UNITED STATES PATENT AND TRADEMARK OFFICE

10/669,554

Wolfgang Rentzsch

Office Action Summary	Application No.	Applicant(s)	
	10/669,554	RENTZSCH, WOLFGANG	
	Examiner	Art Unit	
	Davienne Monbleau	2878

Yasushi Fig. 6

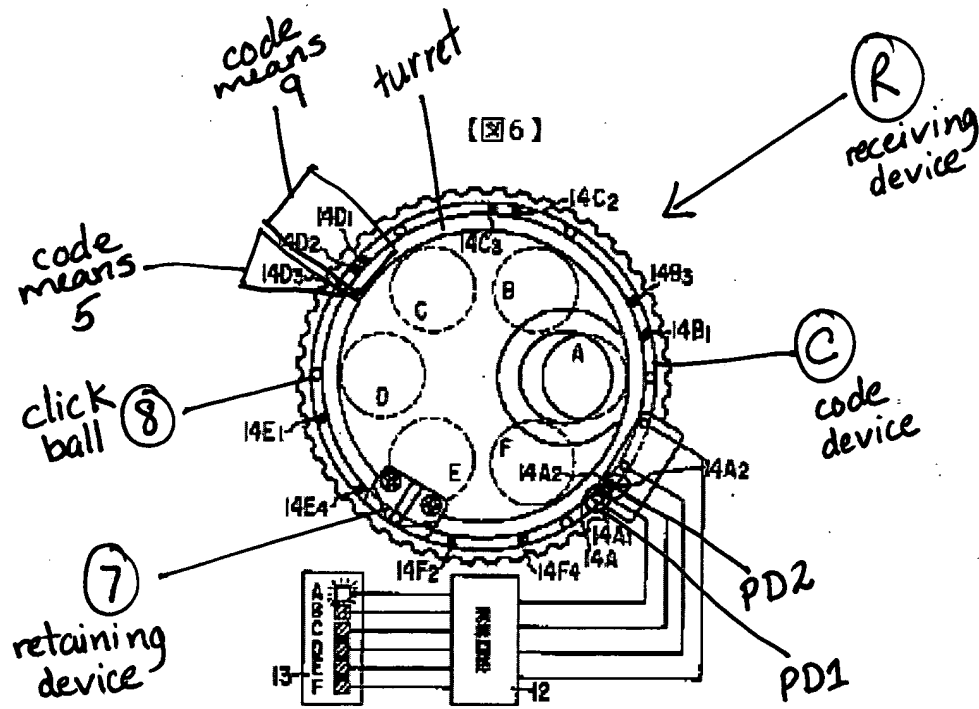
Regarding Claim 1, *Yasushi* discloses in Figures 1 and 6 an apparatus for positioning an optical component, arranged in a receiving device (R) together with several optical components (1A-1F), said apparatus comprising a receiving device (R) being rotatable about an axis and being retainable in several retention positions, said optical component being positionable in a corresponding retention position, a coding device (C) having coding means (14D1, 14D2, 14D3), and two detectors (PD1, PD2) detecting the coding means (14D1, 14D2, 14D3), said two detectors (PD1, PD2) being associated with said receiving device (R) for detecting position of said receiving device (R), and the two detectors (PD1, PD2) detecting coding means (14D1, 14D2, 14D3) at spatially different points, said coding device (C) being embodied in such a way that on the one hand the two detectors (PD1, PD2) detect coding means (14D1, 14D2) simultaneously when the receiving device (R) is located in a retention position, and on the other hand only one of the two detectors (PD1) detects coding means (14D3) when the receiving device (R) is located in a region between two adjacent retention positions. (See Figure 6 below. Please note that Examiner added some notation for clarity in the rejection.)

Regarding Claim 5, *Yasushi* discloses in Figure 6 that coding means (14D1, 14D2, 14D3) are detectable optically.

Regarding Claim 6, *Yasushi* discloses in Figure 6 that the coding means (14D1, 14D2, 14D3) are reflective regions that are arranged substantially transversely to the motion direction of the receiving device (R).

Regarding Claim 8, *Yasushi* discloses in Figure 6 a retaining device (7) arranged in stationary fashion and retains the receiving device (R) in a retention position.

Regarding Claim 9, *Yasushi* discloses in Figure 6 that the retaining device (7) encompasses a ball (8), mounted with force impingement, that as a result of the force impingement presses into a locking notch provided on the receiving device (R). The retaining device (7) is a click spring and thus inherently uses force impingement with a notch.

Regarding Claim 10, *Yasushi* discloses in Figure 6 that the two detectors (PD1, PD2) are arranged with respect to one another in such a way that they detect the coding means (14D1, 14D2, 14D3) at an effective distance D.

Regarding Claim 11, *Yasushi* discloses in Figure 6 that the coding device (C) is embodied in such a way that in each retention position of the receiving device (R) there is provided, at the points of the coding device (C) detected by the detectors (PD1, PD2), a coding means (14D1, 14D2) which has an effective width B that is equal to the effective distance D of the detectors (PD1, PD2).

Regarding Claim 12, *Yasushi* discloses in Figure 6 that the coding device (C) is embodied in such a way that there is provided in each retention position of the receiving device (R), at the points of the coding device (C) detected by the detectors (PD1, PD2), a coding means (14D1, 14D2) which has an effective width B that is less than the width E of the capture region of the retaining device (7).
